**From:** Youngsma, Lucas (DNR) <lucas.youngsma@state.mn.us>  
**Sent:** Tuesday, January 29, 2019 11:21 AM  
**To:** Cathy Sue Anderson (cathy.anderson@granitefalls.com); Domeier, Chris R (DNR); Losinski, Jeremy (DNR)  
**Subject:** Floodwall near U/S Portage, Granite Falls

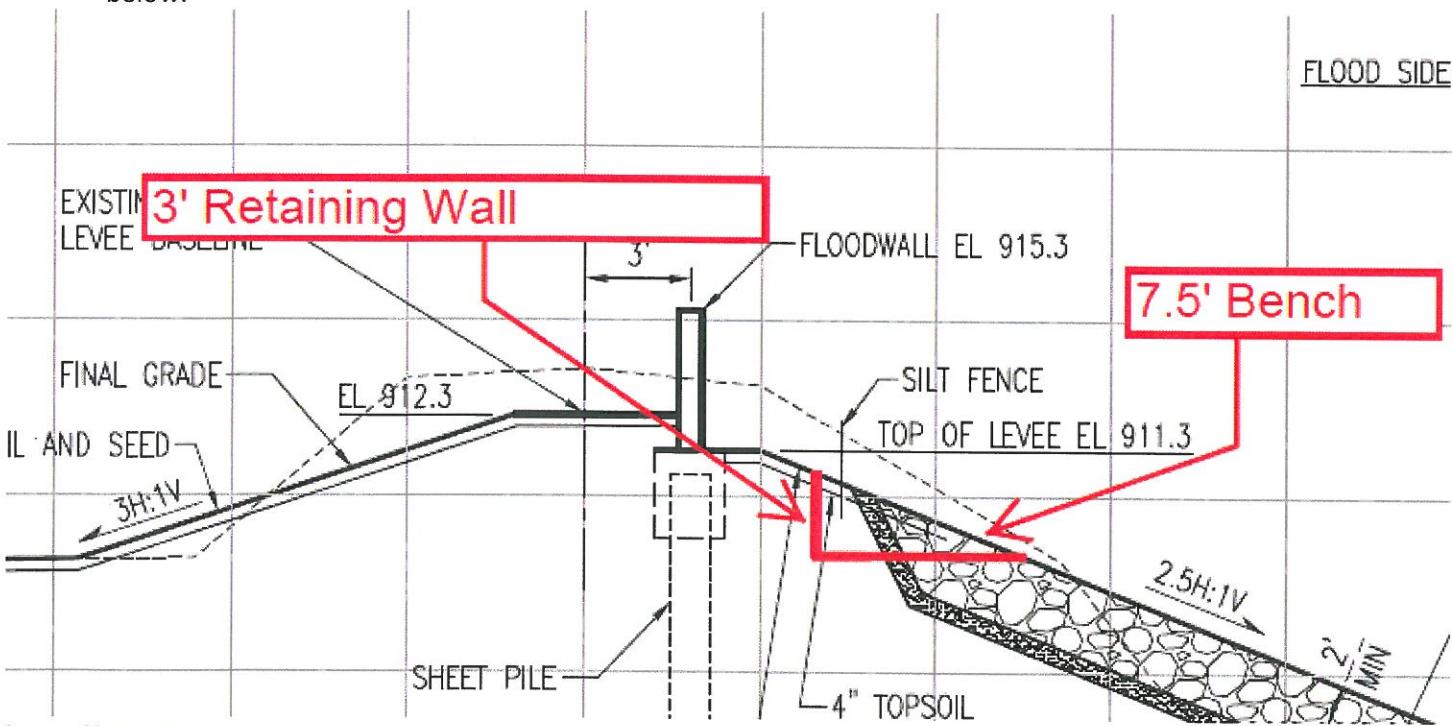
3. Costly, but geotechnical stability seems possible, multiple regulatory review steps, risk addressed by construction methods: excavate 3' down and install a structural retaining wall on the river side. Install 7.5' wide walkway, ~175' long, ~elevation 908. Add treated timber stairs at roadway to come up 7-8' to roadway. Visual below.
